Project Name: WellingtonTownhomes – Final Plat & Plan

FILE NO. 38-79 (2 of 2) DUE DATE 11/13/81
 ACTIVITY Wellington Condominiums
 PHASE Revised Preliminary Plan ACRES 1.70
 LOCATION 225' E. of 12th St. between Wellington and G.V. Canal
 PETITIONER Paul Smith
 PETITIONER ADDRESS 2579 H 3/4 Rd., Grand Junction, CO 81501
 ENGINEER Colorado West Engineering

FILE NO. 38-79 2/2 TITLE HEADING Wellington Townhomes DUE DATE 6/11/82

WELLINGTON TOWNHOMES
FINAL PLAN

DESIGNED BY: J.M.	DATE 11/81	STATION STA. TO STA.	WELLINGTON TOWNH REVISED PRELIMINARY PLAN
DRAWN BY: B.C.P.	DATE 11/81	SCALE HORIZ. 1" = 20'	
COLORADO WEST ENGINEERING CONSULTING CIVIL ENGINEERS 808 COLORADO AVE., GRAND JUNCTION, COLORADO 81501 (930) 240-5112			CLIENT: PAUL SMITH

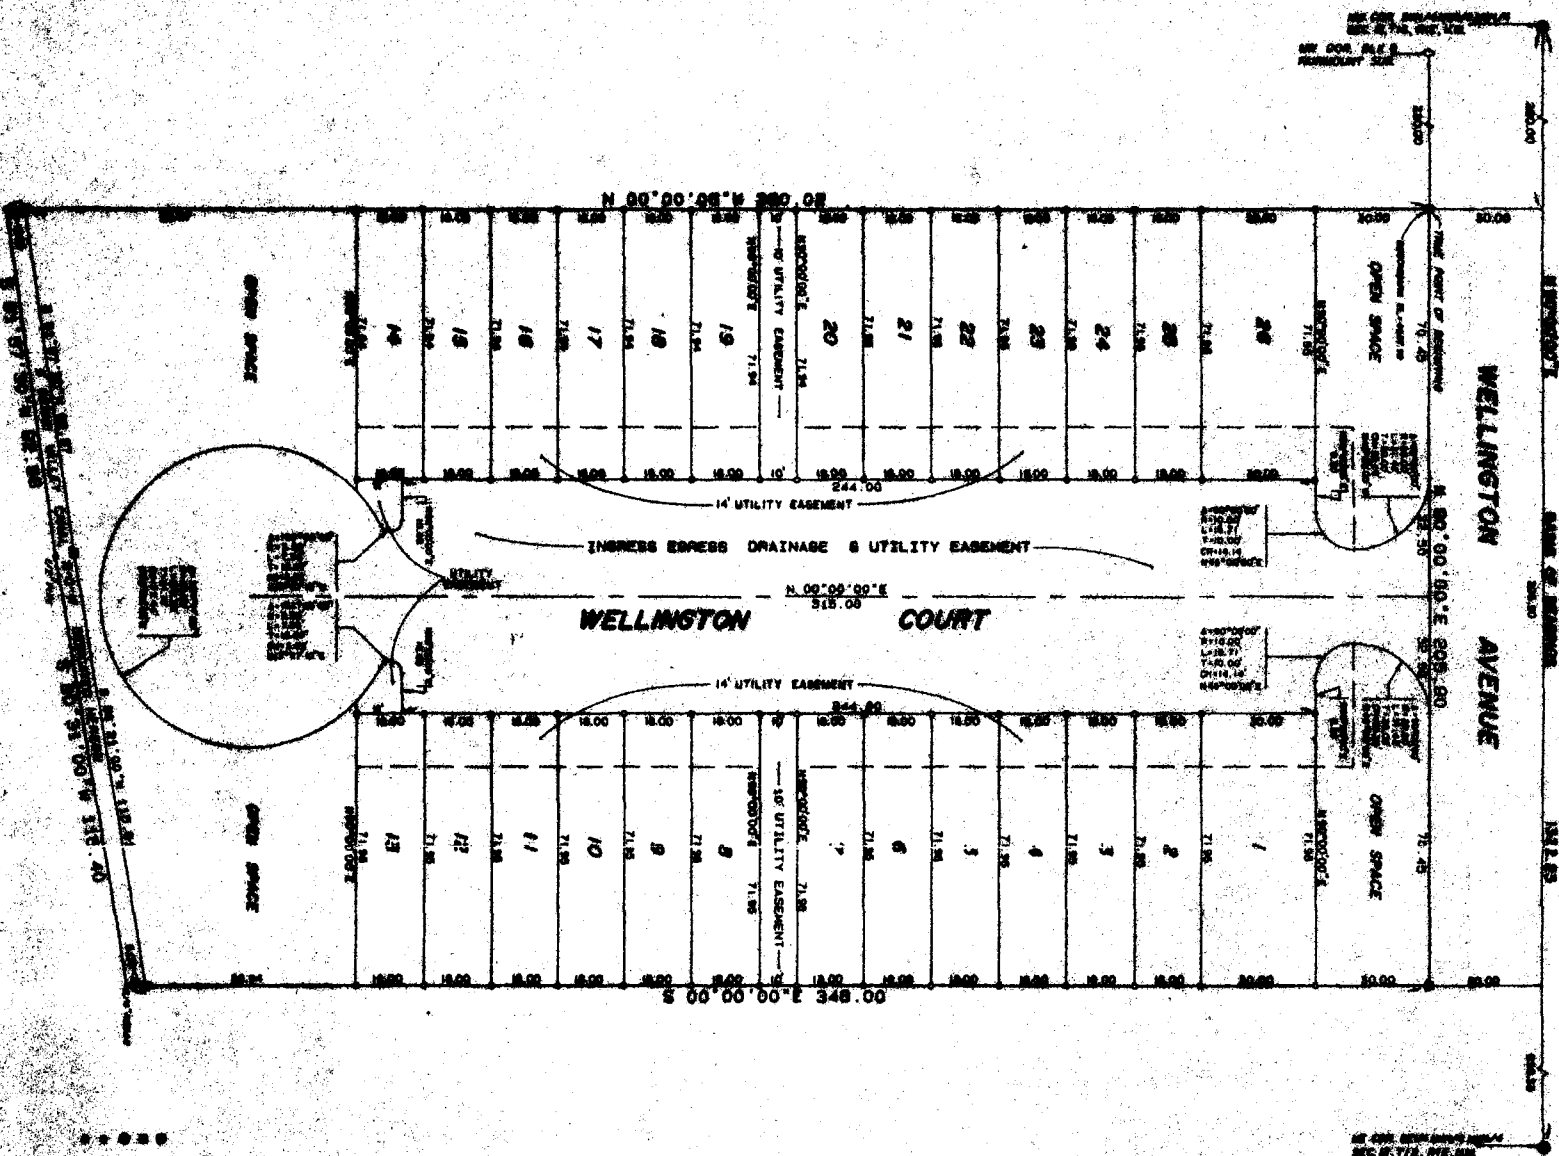
<u>DATE REC.</u>	<u>AGENCY</u>	<u>COMMENTS</u>
11/5/81	City Utilities	Large trash trucks will not be able to service trash tank at location shown. If cars are parked in the adjacent spaces the truck will have to back out. This is too hazardous.
11/12/81	City Parks/Rec.	It would be better to have more diversity than 1 type deciduous tree, upright juniper and spreading juniper. By using various plant materials you could give some sense of identity to an otherwise mirror image development. Deciduous trees could include Washington Thorn, Russian Olive, Hackberry, Goldenrain Tree, Purpleleaf Plum or Littleleaf Linden. Upright Junipers could include Ames, Blue Point, Moffett, Mountbatten, Robusta Green, Spartan, Blue Haven, Pathfinder, Welch, Canart, Ketebeer, or Dundee Junipers. Spreading Junipers could include Sea Green, Gold tipped Pfitzer, Broadmoor Blue Danube, Buffalo, Compact Pfitzer, or Hughes Juniper.

11/12/81	City Fire	Hydrant placement on 8 inch main as shown on plot plan acceptable for Fire Protection. Hydrants to be installed before construction begins. Wellington Court to be constructed according to city codes. The fire dept. will require a turn around at the south end of Wellington Court capable of allowing fire dept. apparatus to turn around.

<u>DATE REC.</u>	<u>AGENCY</u>	<u>COMMENTS</u>
11/12/81	Staff Comments	Density approved is PR-16, with 28 units on 1.7 acres, the overall density is 16.47 units/acre. <ol style="list-style-type: none">1) What type of amenities are being proposed?2) What is the percent of total open space?3) Open area is not indicated on plan.4) Lighting scheme detailed.5) Trash pick-up needs to be coordinated with Bill Reeves.6) Parking stalls need dimensions and parking area be paved and striped.7) Need height elevation and dimension of structures.8) Need adjacent land use and zoning shown on plan.9) Principal structure setbacks need to be indicated on plan.10) Utility easement in parking area needs to be dimensioned and indicated on plan.
		Project must obtain Building Permit within 1 year of final approval or be scheduled for a rehearing.
11/13/81	Mountain Bell	Proposed utility easements and open space should be adequate for the telephone lines.

11/13/81	Public Service	Electric: No objections to "Revised Preliminary Plan"; except electric requests a utility easement East & North of Grand Valley Canal. THI 11/10/81 Gas: No objections to revised preliminary plan. HT 11/12/81
11/13/81	Transportation Engineer	The traffic circulation pattern is not acceptable. In fact, there is no provision for traffic circulation. What is shown is a 320' semi-cul-de-sac, with no turn-around at the end, and 90° parking on both sides. Any large vehicle (trash truck, fire truck, moving van, etc.) entering the parking area would be forced to back out onto Wellington Ave.
11/16/81	City Engineer <i>Late</i>	Estimated completion dates not shown on Improvements Agreement. Power-of-attorney for Wellington Street improvements should be recorded with the plat. Typical 60 ft. street section shown is incorrect Wellington is a "local" street in a residential area. A 20 ft. wide easement should be provided on the sanitary sewer. Plans and a 10 ft. wide easement should be provided for the drainage outlet to 12th Street. Detailed construction plans for the sanitary sewer should be submitted to me prior to construction. Traffic circulation is terrible. No provision is made for a turn-around at the south end of the parking lot. Does the trash dumpster have to be so far away from the street?

11/17/81	Additional Staff Comments	<ol style="list-style-type: none">1) Extensive screening to the front half of this development should be assured, especially adjacent to the single family residents.2) Existing vegetation should be saved, wherever possible.
11/25/81	Mountain Bell <i>Late</i>	The easements on this plat are adequate for our use.
11/23/81	Radiation & Hazardous Wastes Control Div.	The Radiation and Hazardous Wastes Control Division has reviewed the material which was submitted to this office pursuant to the radiation hazard evaluation requirements of 30-28-133, C.R.S., 1973 (Senate Bill 35). Based upon the gamma radiation survey results report by Arix, radioactive materials are present on the subdivision. This material should be removed from the site prior to the commencement of any other construction activities. The material should be moved to the Colorado Department of Health tailings repository in Grand Junction.

WELLINGTON AVENUE

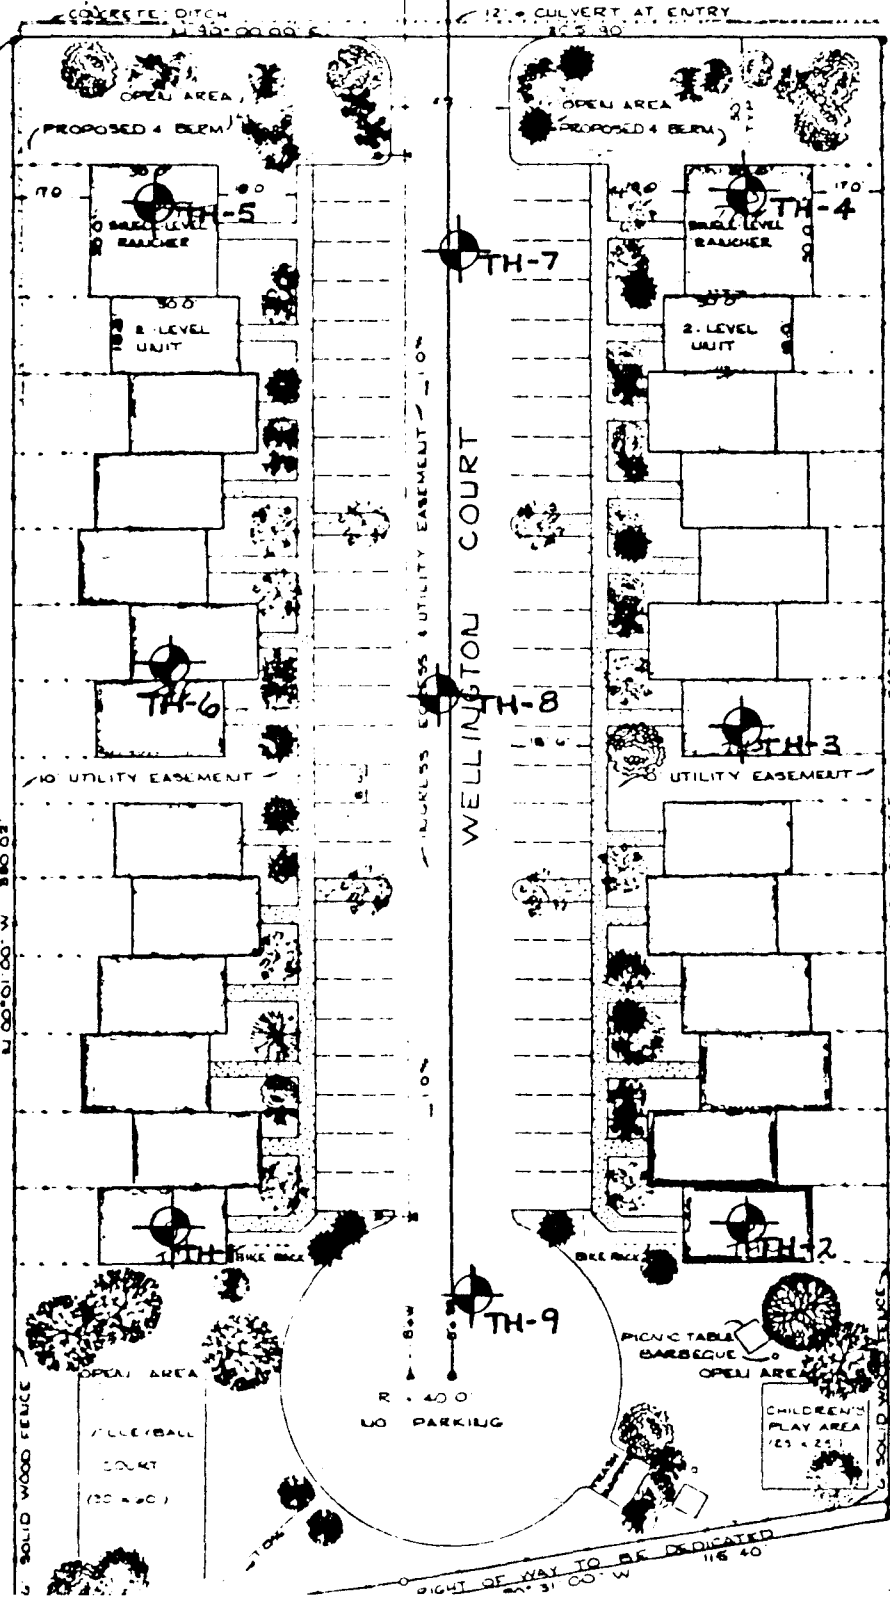
SEE DRAWING TO BE CHANGED TO LEFT STREET AS DISCUSSED WITH ENGINEER EASEMENT TO BE LEGOT. PRIOR TO FINAL SUBMITTAL.
